Black Start Problem Statement / Issue Charge

Black Start Unit Involuntary Termination and Substitution Rules

Operating Committee

August 6, 2020

CRF calculated at time of Black Start in-service date

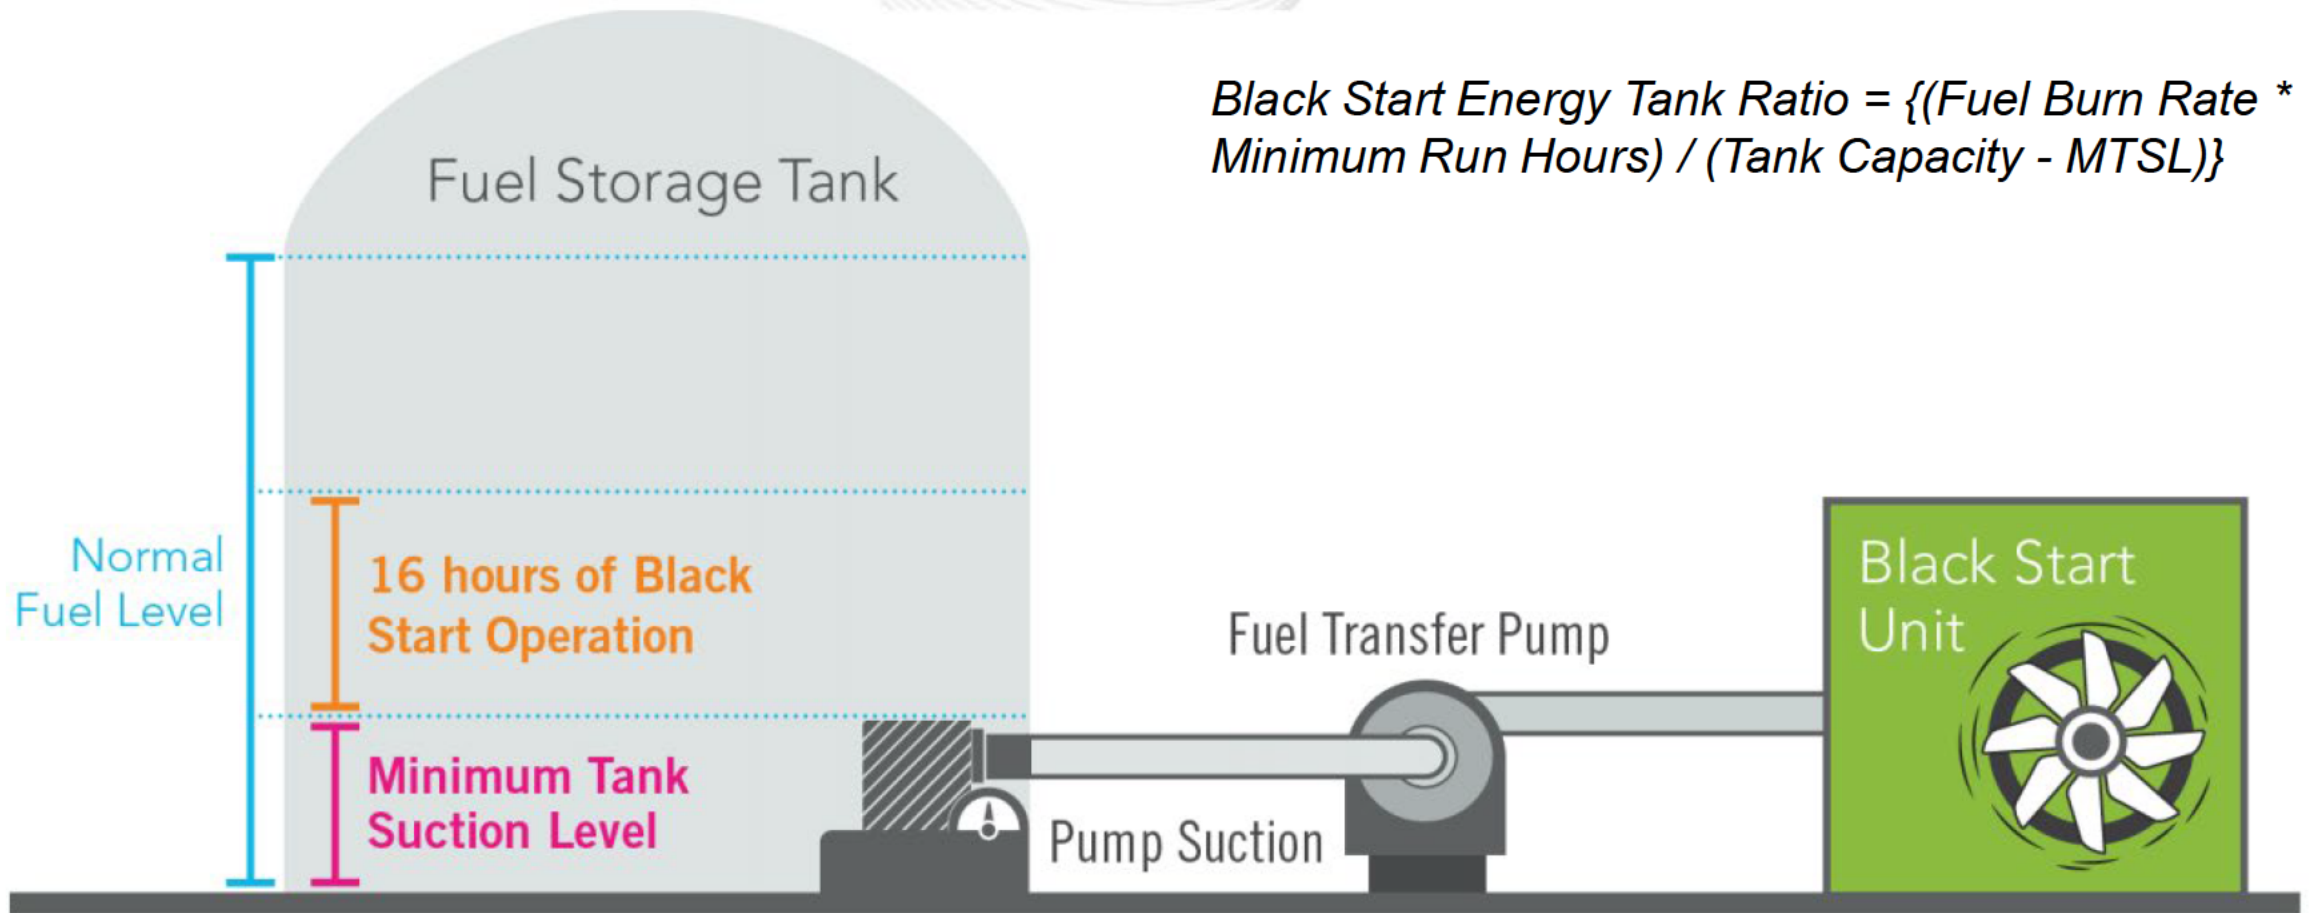
- Depreciation as applicable under the tax code as applicable to the Black Start Unit
- **Current Federal Tax Rate**
- Average State Tax Rate
- **Interest rate - Moody's Utility Bond Index for Baa1**
- Return on equity of 12 percent
- 50 Percent Equity
- 50 percent Debt
- (*PJM*) 5, 10, 15 & 20 year recovery period based on existing unit age
- (*IMM*) 10 & 20 year recovery and commitment to provide Black Start Service for the life of the unit

- CRF re-calculated annually (based on April 1st references and effective June 1st for new annual revenue requirement)
 - Changes to Federal Tax Rates
 - Interest rate – only changes if cumulative difference is 2 percentage points greater than the 12 month bond index rate two years ago for the Moody's Utility Bond Index for Baa1
 - *Black Start Units selected in recent RFPs under a Capital Recovery Rate TBD*

- Capital Recovery Factor (CRF) Table to be removed from Open Access Transmission Tariff, Schedule 6A Black Start Service.
 - New Section in PJM Manual 15 for CRF calculation method and assumptions
 - Annual CRF Tables posted to PJM's website
